**Subject: SoGreen and Parramore Fertilizer Sites
Semi-Annual Progress Report No. 1 required under Consent Order No. EPD-VRP-015**

**Subject: Response to October 31, 2017 EPD Comments
SoGreen Former Waste Pile Site**

In conjunction with the submittal of the Voluntary Remediation Program (VRP) February 2019 Progress Report #1 for the above-referenced site (SoGreen), this letter provides a response to EPD's October 31, 2017 comments on the Site Voluntary Investigation Remediation Plan (VIRP) dated May 5, 2017.

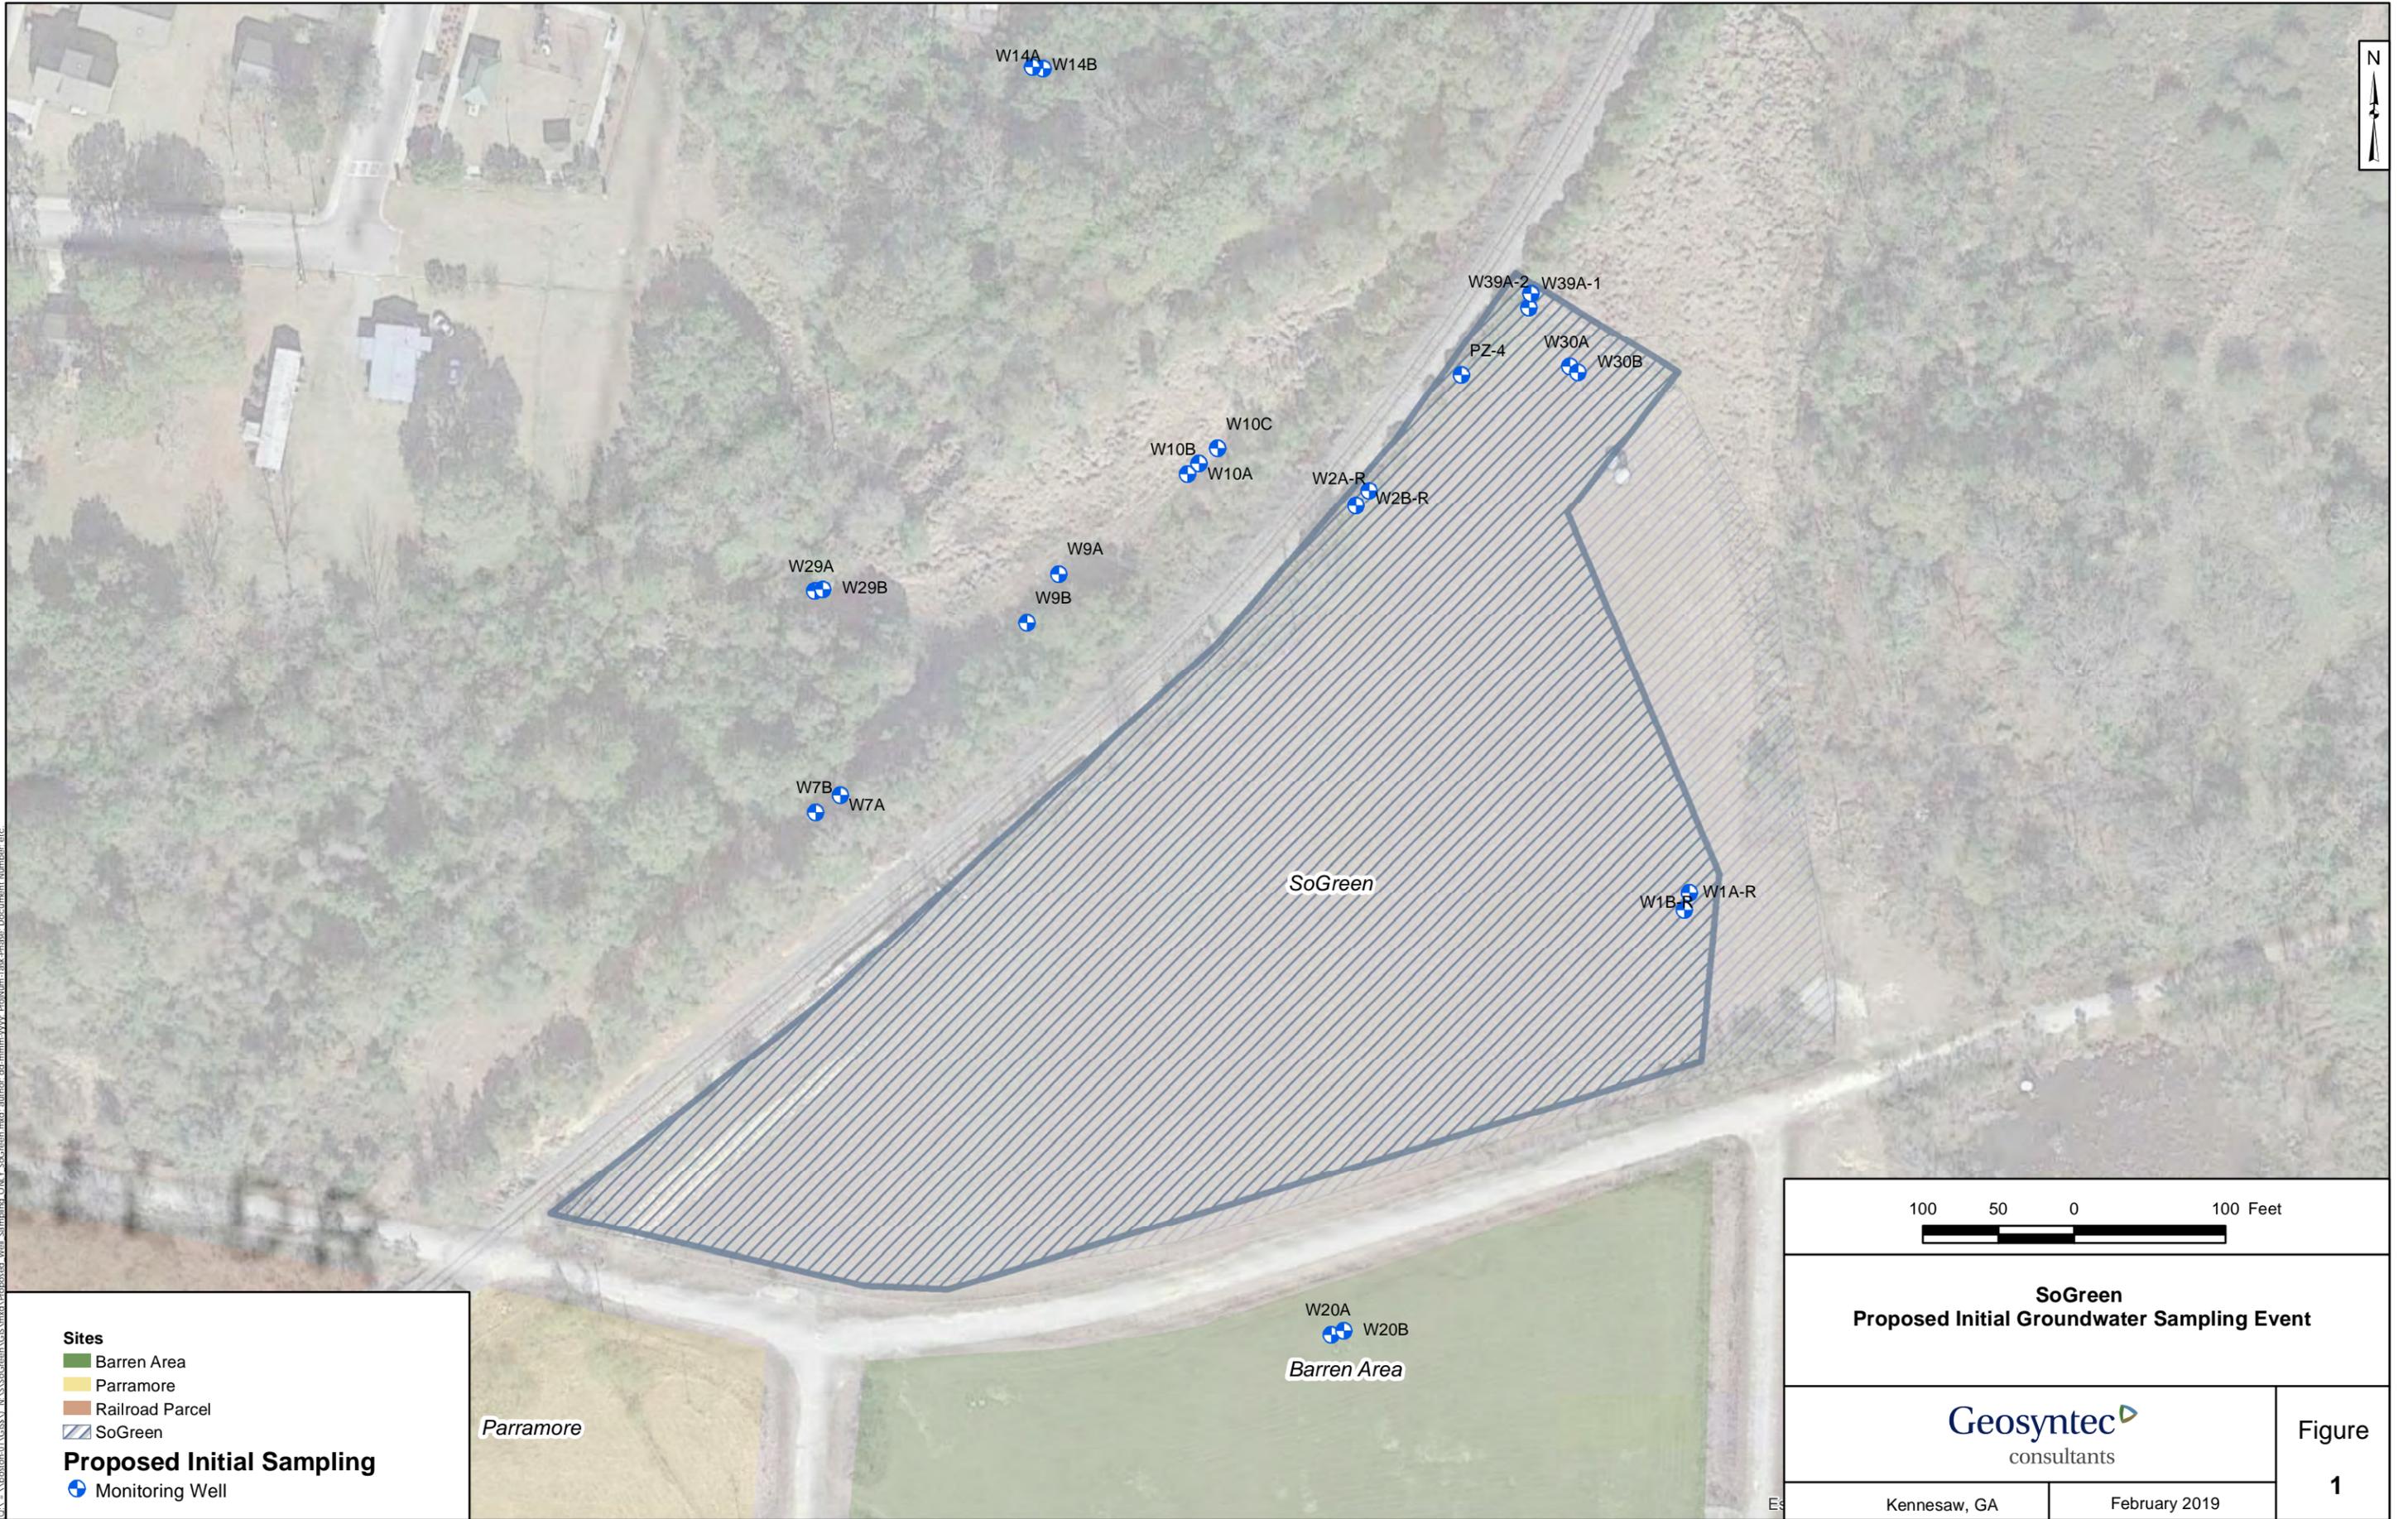
Please update the groundwater sampling approach in Section 5.3.1 of the VIRP to include a list of the specific monitoring wells proposed to be sampled and rationale for the selection of wells to be incorporated into the site related monitoring plan. EPD requests that this information be provided 45 days prior to the first sampling event.

Section 5.3 and Appendix C provide limited information regarding the construction of the proposed piezometers and monitoring wells. The first progress report should include information regarding the proposed well depths, well screen slot size, and well development method. The document should reference that the wells will be installed in

The specific wells to be sampled and associated rationale for the baseline VRP sampling event are provided on the attached table and figure. The wells and analyte list for future

The location and approximate depth of proposed piezometers and wells is provided in the attached table and figure. Piezometers and monitoring wells will be installed in general accordance with the above referenced EPA SESD guidance.
